ADDENDUM NO. 3

DATED: November 14, 2024

PROJECT:	WSD New Sr. High School	**DATE:**	11/14/2024
OWNER:	Wynne School District	**PROJECT NO:**	A-23010
TO:	Gary Hoyt Nabholz Construction	**CONTRACT FOR**:	General Construction

1 THIRD FLOOR PLAN : AREA A SOUTH - NOTE

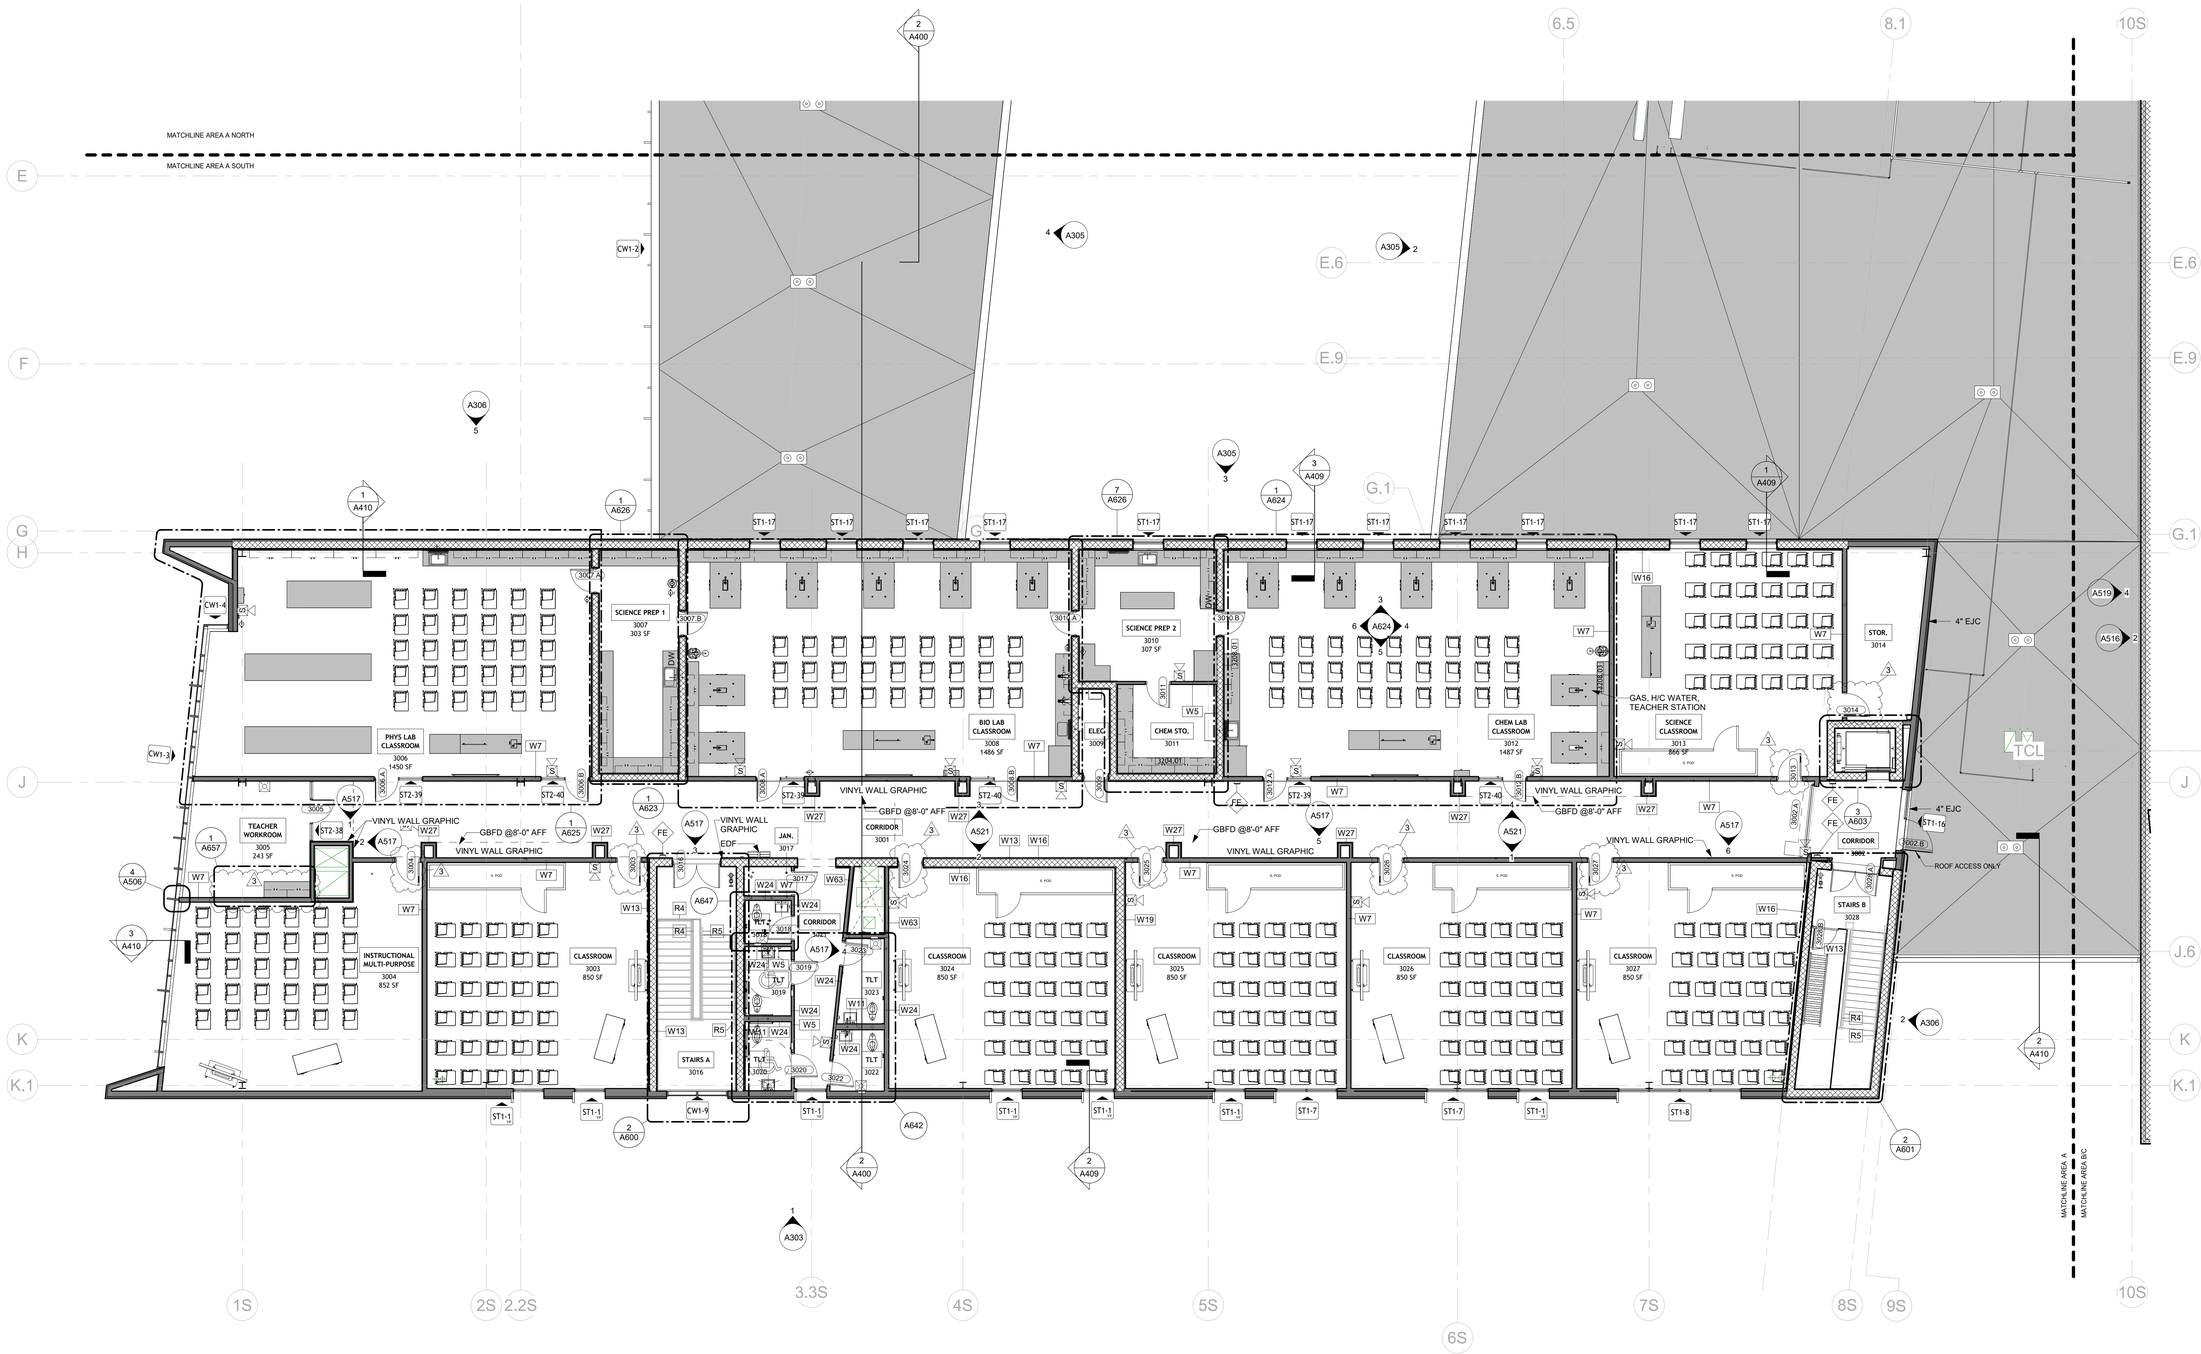
44. Sheet A119 THIRD FLOOR PLAN -OVERALL: See clouded revision ADD. 3
45. Sheet A120 THIRD FLOOR AREA A SOUTH -NOTE PLAN: See clouded revision ADD. 3
46. Sheet A121 THIRD FLOOR AREA A SOUTH -DIMENSION PLAN: See clouded revision ADD. 3

ENLARGED PLAN - CE-AG-2 AGRI

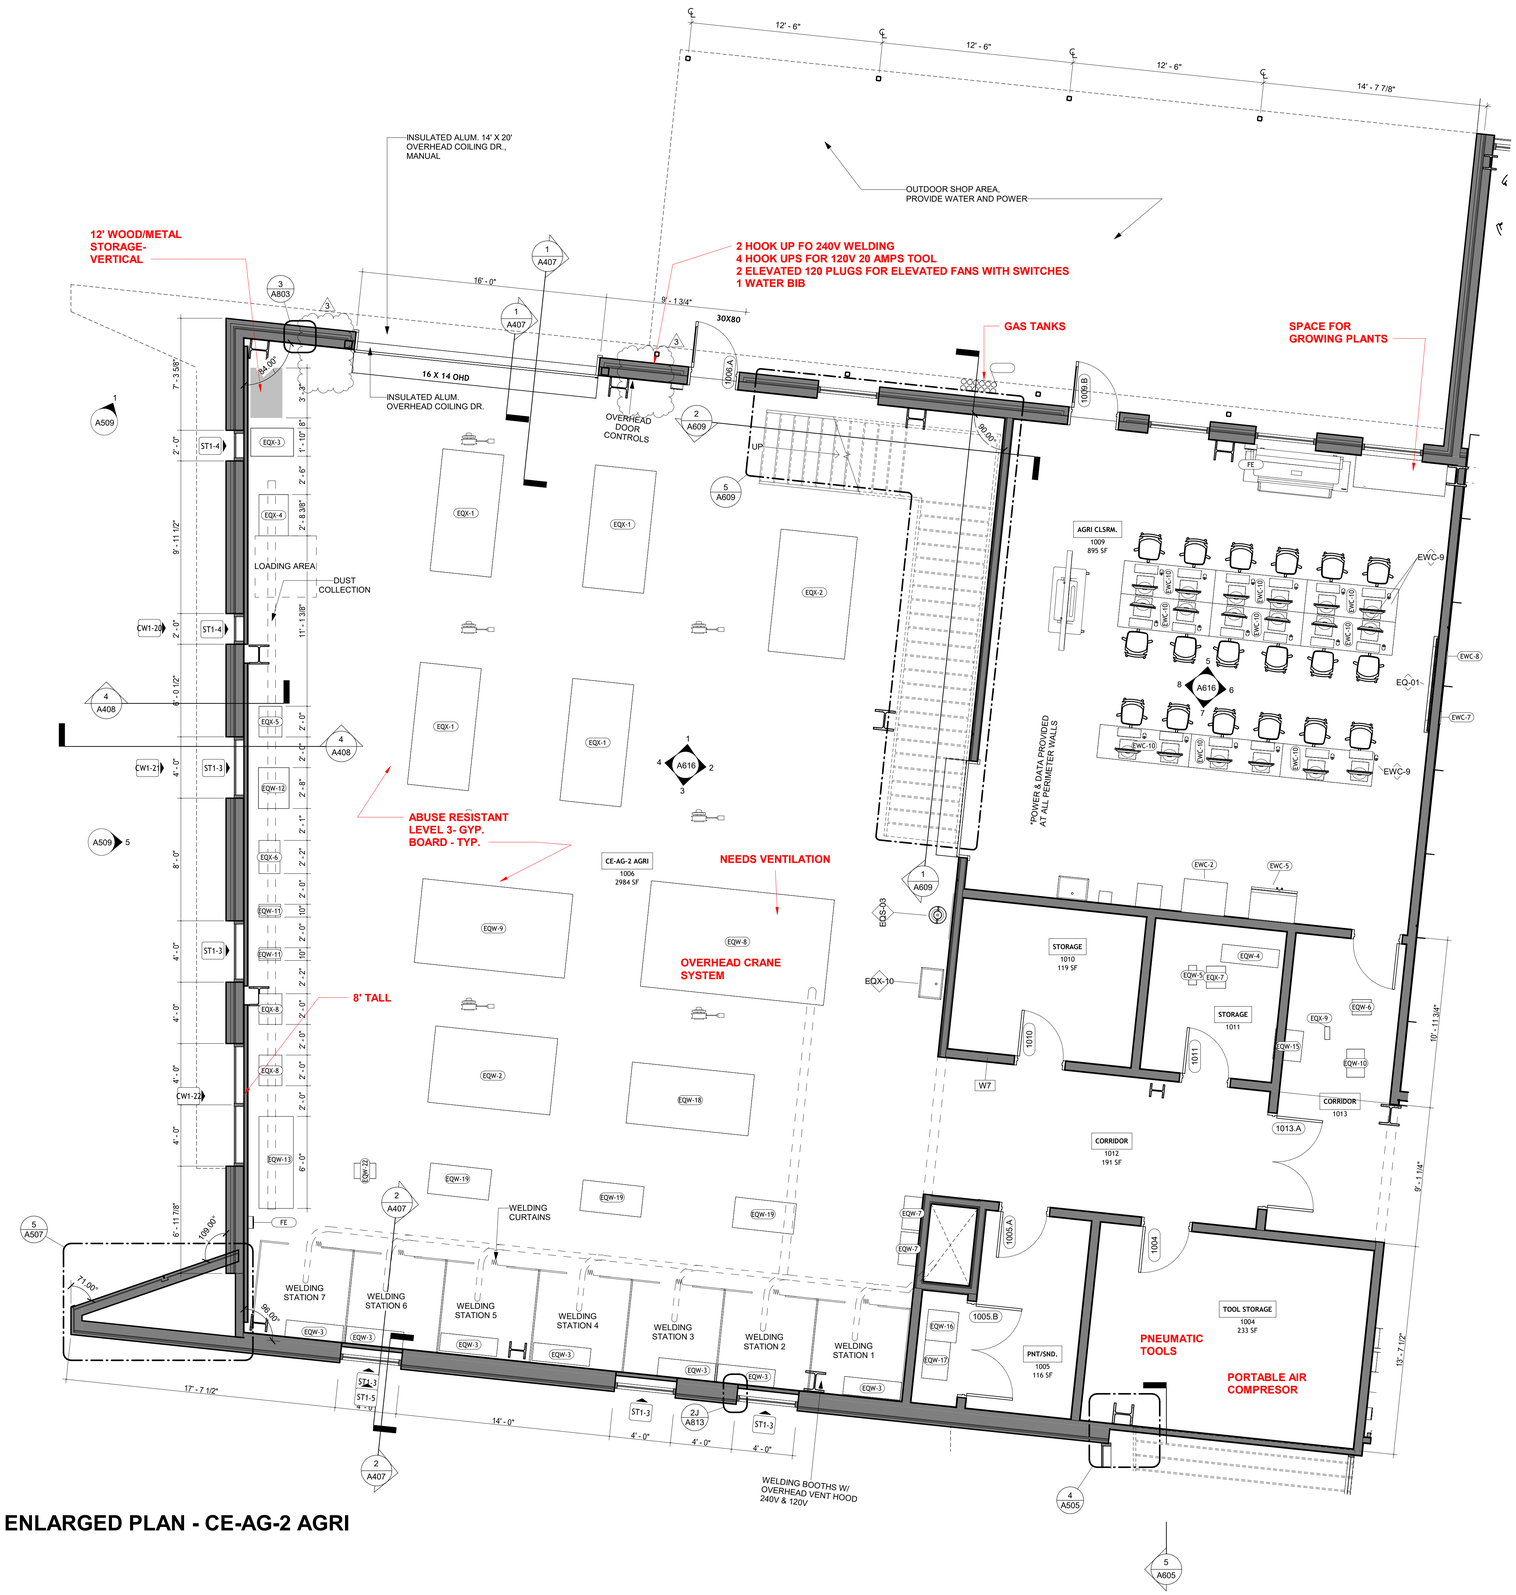
55. Sheet A615 ENLARGED PLANS CE-AG-2 AGRI PLANS: See clouded revision ADD. 3
56. Sheet A634 ENLARGED TOILET PLANS & ELEVATIONS: See clouded revision ADD. 3

1 ENLARGED AUDITORIUM - FIRST FLOOR LIGHTING

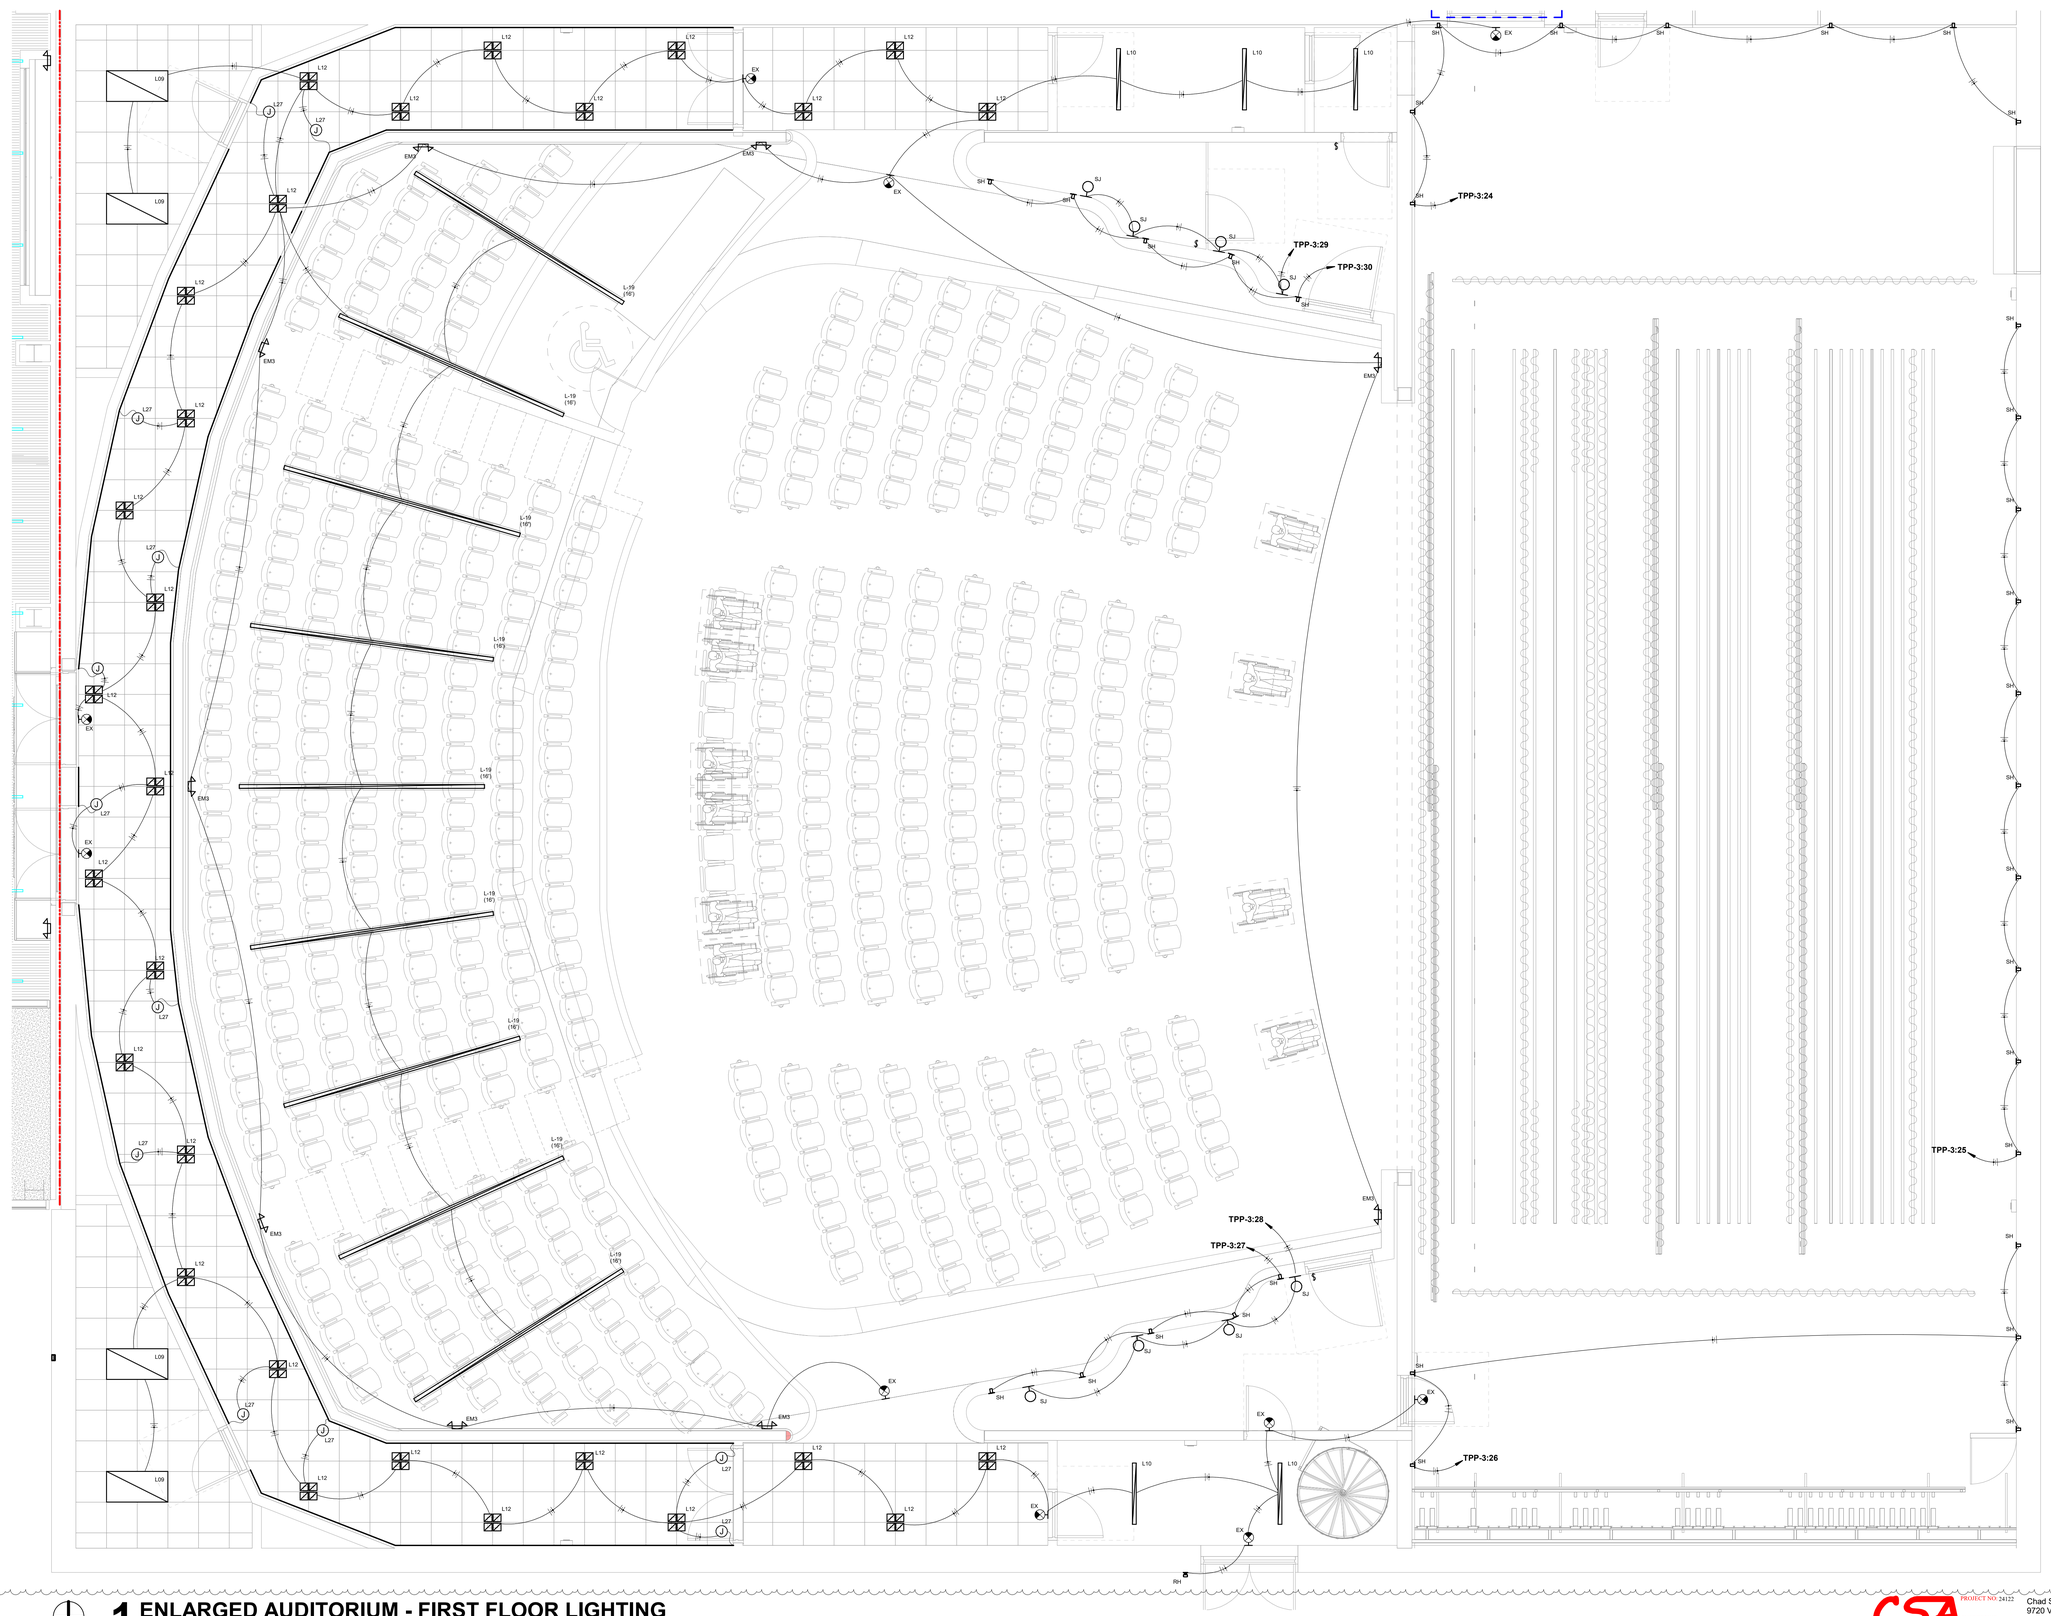
117. Sheet E201.1 FIRST FLOOR PLAN – AREA A NORTH: Drawing has been updated and revised as indicated on drawing sheet.
118. Sheet E302 ENLARGED AUDITORIUM: Drawing has been updated and revised as indicated on drawing sheet.

SHEET NUMBER
M101.3

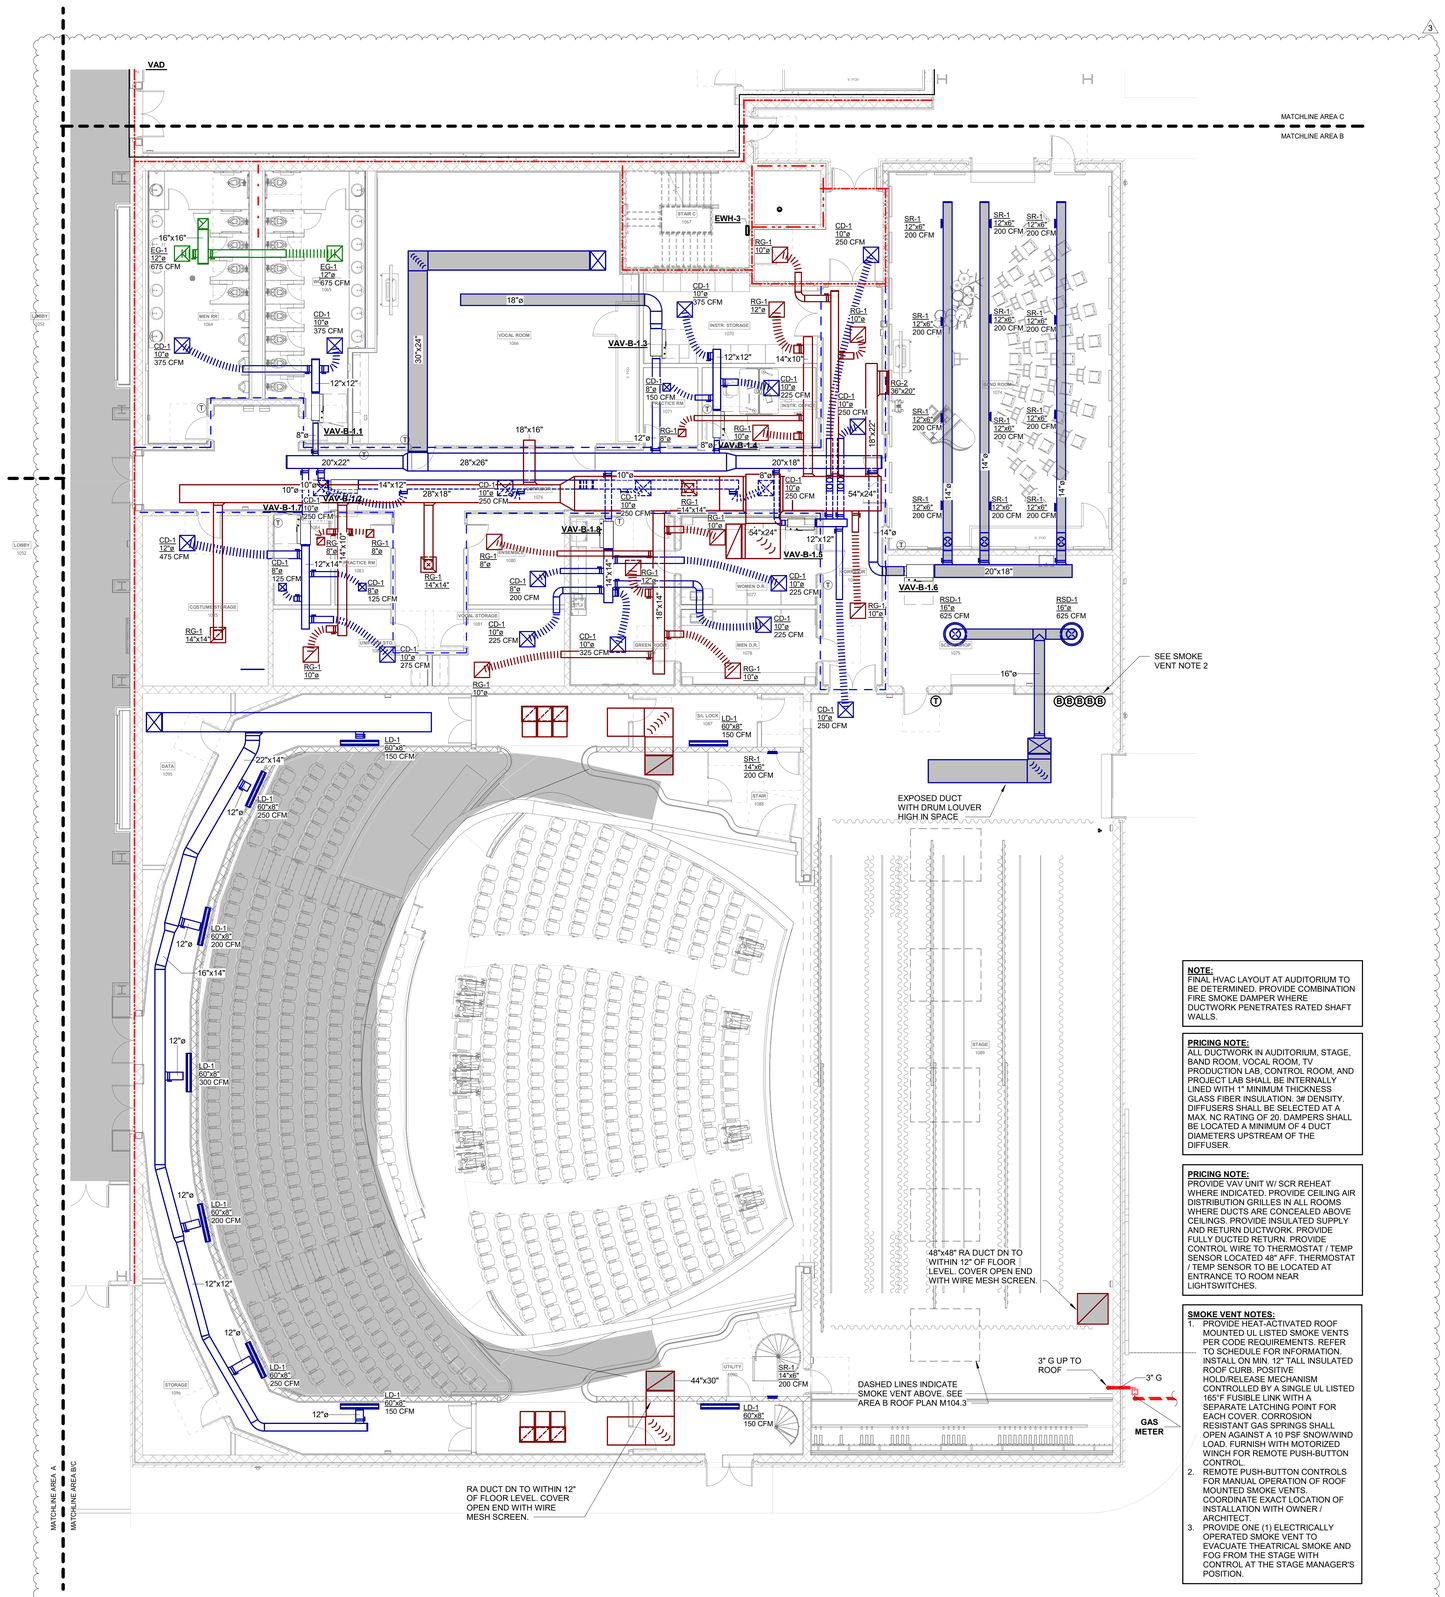
100. Sheet M101.3 FIRST FLOOR PLAN – AREA B - MECHANICAL: Drawing has been updated and revised as indicated on drawing sheet.
101. Sheet M102.2 SECOND FLOOR PLAN – AREA A SOUTH - MECHANICAL: Drawing has been updated and revised as indicated on drawing sheet.
